EMERGENCY AIRWORTHINESS DIRECTIVE

Number: G-2021-0010-E

CAMERON BALLOONS Ltd

ATA 28 – Fuel –Cylinder Quick Shut-off Valve Mounting Flange – Inspection / Replacement

Figure 1: *CB437 Flanged Adaptors for Quick Shut-Off (QSO) valves*

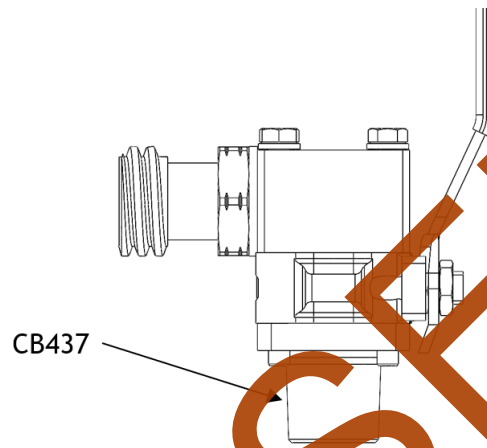
Certain Cameron Hot Air Balloon fuel cylinders are supplied with liquid offtakes that consist of a quarter turn ball valve mounted on a flanged adaptor (P/N CB437, see figure 1). Two recent batches of these adaptors have been manufactured with non-conforming (undersize) threads.

In certain cases, when the minimum sized adaptors are combined with cylinder bosses at maximum tolerance dimension and assembled to fuel cylinders, the thread can impinge (“bottom out”) on the cylinder boss. Although the required tightening torque value can be achieved at installation, the torque required to unscrew the flange could be below the minimum value. In extreme cases the adaptor may be unscrewed by hand.

For the reasons described above, this AD requires a one-time inspection of each affected fuel cylinder for leakage around the threaded joint between the QSO valve adaptor flange and the cylinder boss and, depending on findings, removal from service of the affected fuel cylinder. This AD also requires modification of each fuel cylinder by replacement of the affected part with a serviceable part.

4. From the effective date of this AD, do not install an affected part on any cylinder.
5. Within 4 months after the effective date of this AD, modify each cylinder by replacing the P/N CB437 issue F QSO flanged Adaptor, with a P/N CB437 issue G (or later issue) QSO flanged adaptor in accordance with the instructions of the SB, or by replacing the QSO valve assembly with a handwheel valve part No CB0824-0001 (this part has a Rego-type hose connection).
